#### Endangered and Threatened Wildlife; Sea Turtle Conservation Requirements

**ACTION:** Final rule.

**SUMMARY:** NMFS is amending the turtle excluder device (TED) regulations to enhance their effectiveness in reducing sea turtle mortality resulting from trawling in the southeastern United States. NMFS has determined that: some current approved TED designs do not adequately exclude leatherback turtles and large, immature and sexually mature loggerhead and green turtles; several approved TED designs are structurally weak and do not function properly under normal fishing conditions; and modifications to the trynet and bait shrimp exemptions to the TED requirements are necessary to decrease lethal take of sea turtles. These amendments are necessary to protect endangered and threatened sea turtles in the Atlantic Area (all waters of the Atlantic Ocean south of the North Carolina/Virginia border and adjacent seas, other than the Gulf Area, and all waters shoreward thereof) and Gulf Area (all waters of the Gulf of Mexico west of 81° W. long. and all waters shoreward thereof).

Figure 12 to Part 223

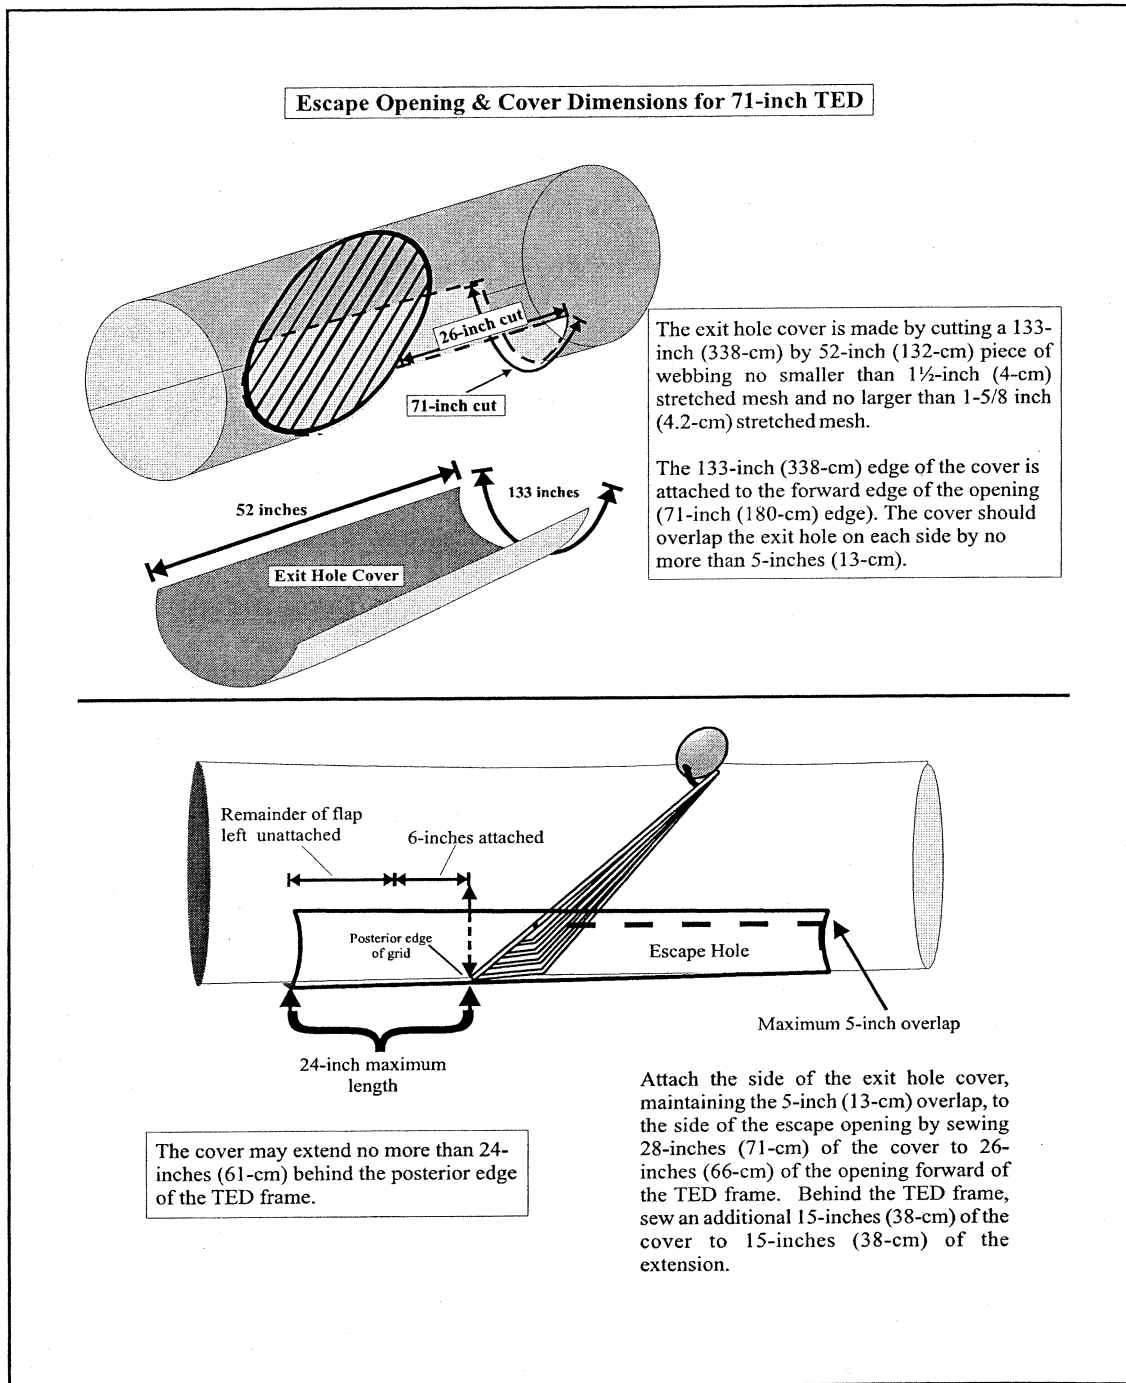
(ii) *71-inch offshore TED Flap*. The flap must be a 133-inch (338-cm) by 52-inch (132-cm) piece of webbing. The 133-inch (338-cm) edge of the flap is attached to the forward edge of the opening (71-inch (180-cm) edge). The flap may extend no more than 24 inches (61 cm) behind the posterior edge of the grid (Figure 12 to this part illustrates this flap).

Figure 15 to Part 223

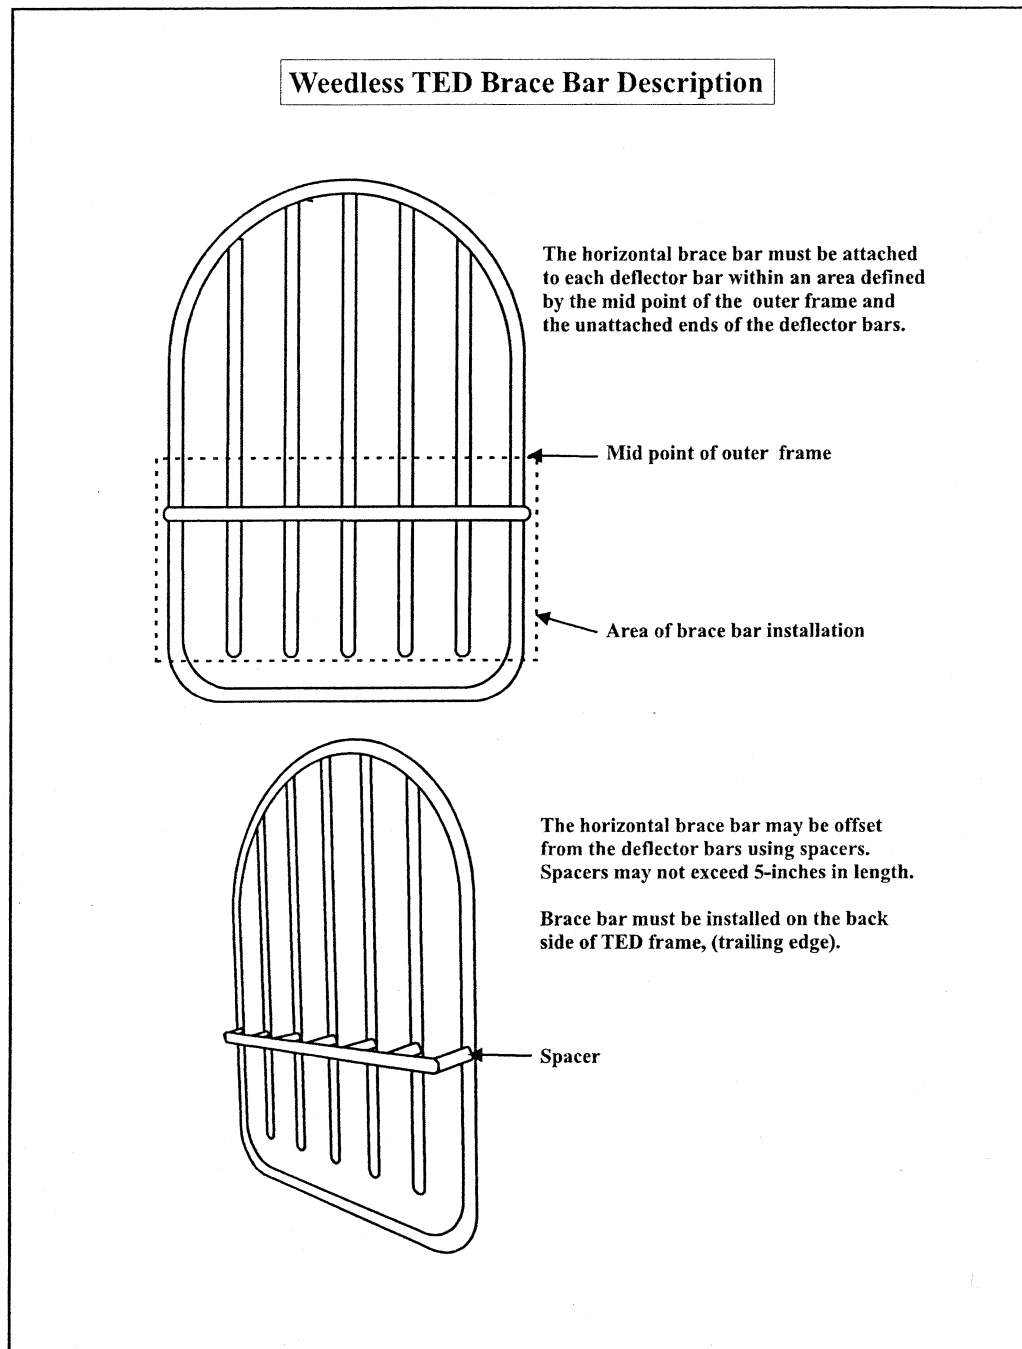
horizontal brace bar may be offset behind the deflector bars, using spacer bars, not to exceed 5 inches (12.7 cm) in length and constructed of the same size or larger pipe as the deflector bars. See Figure 15.
